PRODUCT/PROCESS CHANGE NOTICE (PCN)

PCN #: TB1403-01 DATE: April 9, 2014 Product Affected: TSSOP-14, TSSOP-16 shipped in Tape & Reel (Refer to Attachment II for affected part#) Date Effective: July 9, 2014	MEANS OF DISTINGUISHING CHANGED DEVICES: <input type="checkbox"/> Product Mark <input type="checkbox"/> Back Mark <input type="checkbox"/> Date Code Shipment starting from July 9, 2014 <input checked="" type="checkbox"/> Other
--	--

ATTACHMENT I - PCN #: TB1403-01

From: Carrier Tape (P8-195-P16) - Pocket Dimensions

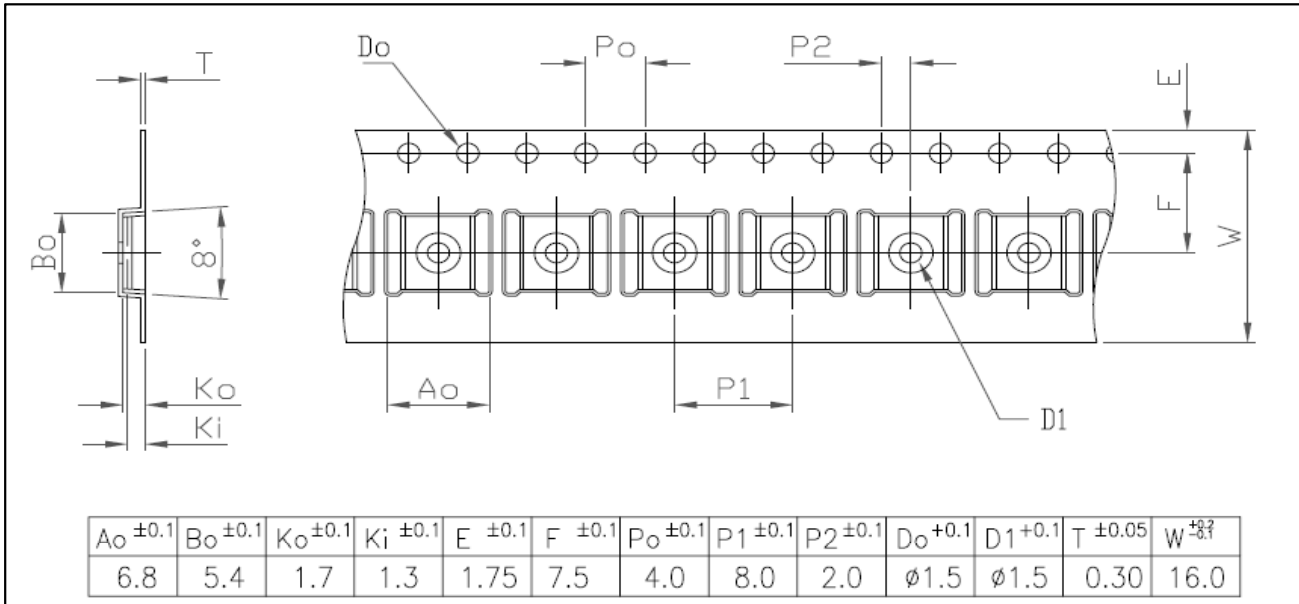
Detail of Change: This notification is to advise our customers that IDT has planned to standardize the following items on TSSOP-14 and TSSOP-16 to only one type as detailed below.

Figure1: Illustration of Carrier Tape Pocket Dimensions

From: Carrier Tape (P8-195-P16)

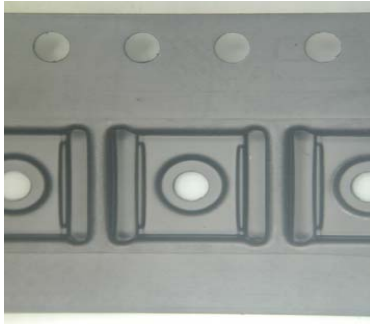
Figure2: Illustration of Carrier Tape Pocket Design

From: 13"/4" Hub Plastic Reel

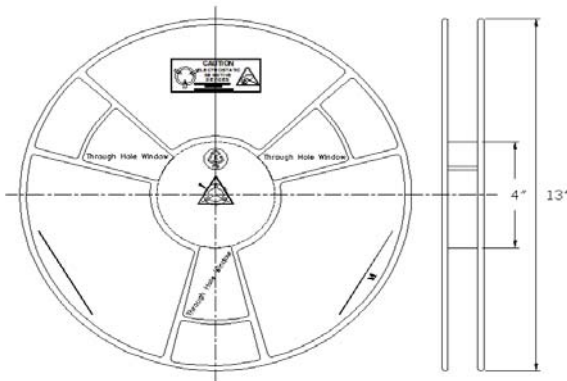
Figure3: Illustration of Plastic Reel
